Technology Inclusive Guidance for Non-Light Water Reactors

Safety Analysis Report Content for Applicants Using the NEI 18-04 Methodology

Prepared by the Nuclear Energy Institute
August 2021

Commented [A1]: Suggested Edit: the NRC has the role of expressing the acceptability of the methods provided in this document for developing portions of the SAR content and would do so in an RG endorsing it with exceptions, additions, and clarifications as appropriate.

Figure 1: Relationship of TICAP to an Advanced Reactor License Application

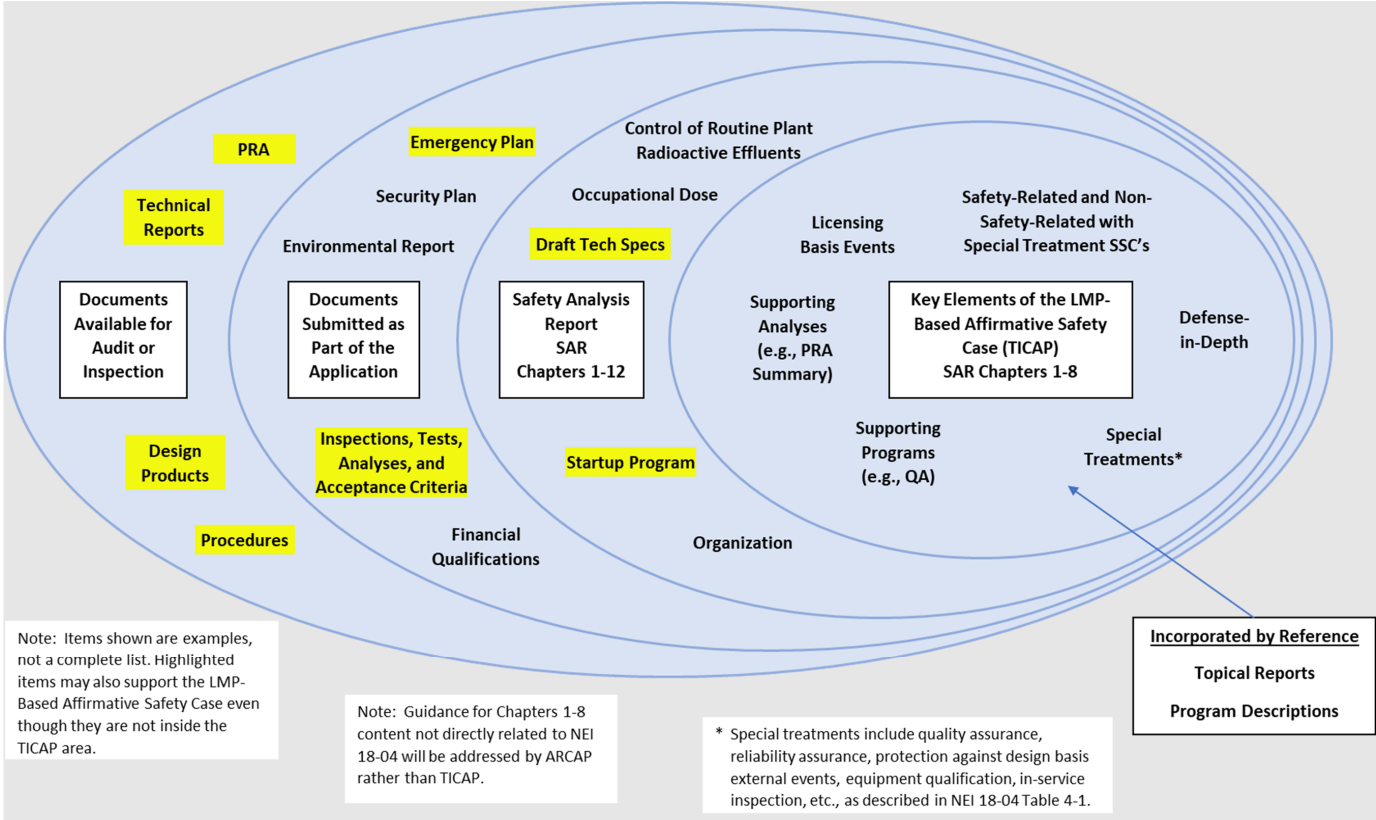
Commented [A9]: Suggested edit: it is not clear why NEI is omitting combined licenses from this list. It might be more effective and efficient to use the regulatory term "a license," which is defined in § 50.2 to include OLs, CPs, and COLs (as well as renewed licenses, which are admittedly out of scope for this guidance).

Commented [A10]: Clarification - Further discussion is needed in either NEI 21-07, Revision 1, or the TICAP draft RG white paper to clarify that that an affirmative safety case should include normal operation and that applicants should also make a licensing case with respect to compliance with regulations and include exemptions, as necessary. That is, the applicant must make the case for and claim compliance with or exemptions from specific regulations. The NRC will not just review the safety case and derive from it those regulations that are met in order to make its findings.

Figure 2: SAR Outline

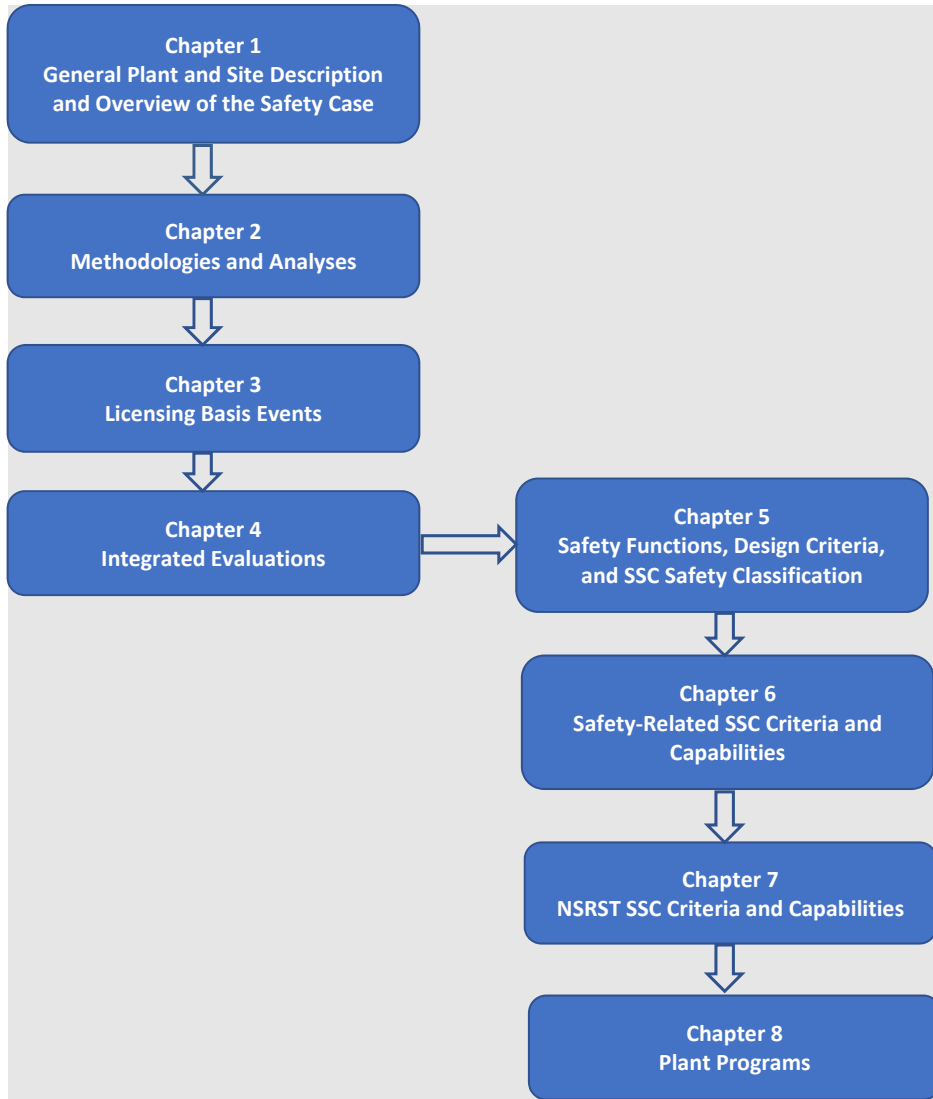
Commented [A11]: Clarification - clarify expectations for an affirmative safety case and the distinction between an LMP-based safety case. That is, an affirmative safety case includes normal operation as well as LBEs.
